LLCC Clarifications in Response to the HCD Staff Report

July 8, 2020

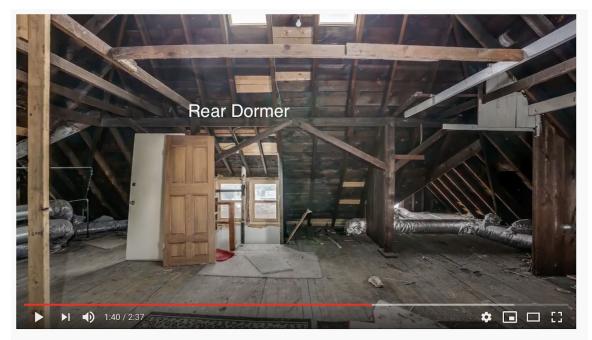
Note - we believe that exposures of 5" and greater are still historically accurate and seen in other homes on the West Canfield block (see photos below)

677 W Canfield St Detroit MI large 039 39 67720West20Canfield20Street2C2 1280x720

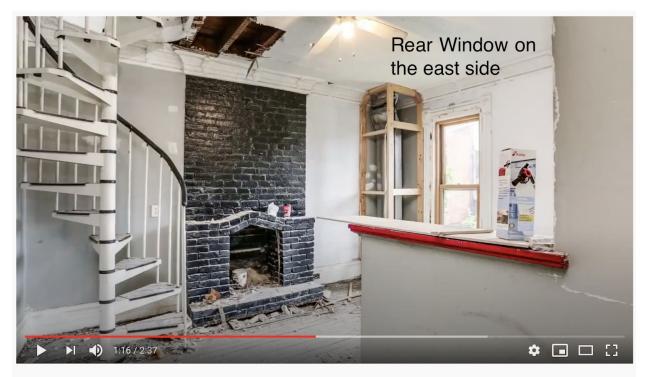
Rear Window violation:

- 1. Rear windows were installed before the homeowners purchased the house.
- 2. Here is a video from Hawkins Reality, who sold the home last to Matt and Kelli.
 - a. <u>https://youtu.be/IATXLuBSHMI?t=70</u> see 1:15, 1:39, 1:48 for view of windows prior to purchase of the house
 - b. This video was posted on August 2, 2018 prior to when they purchased the home in September 2019. *See photos below*
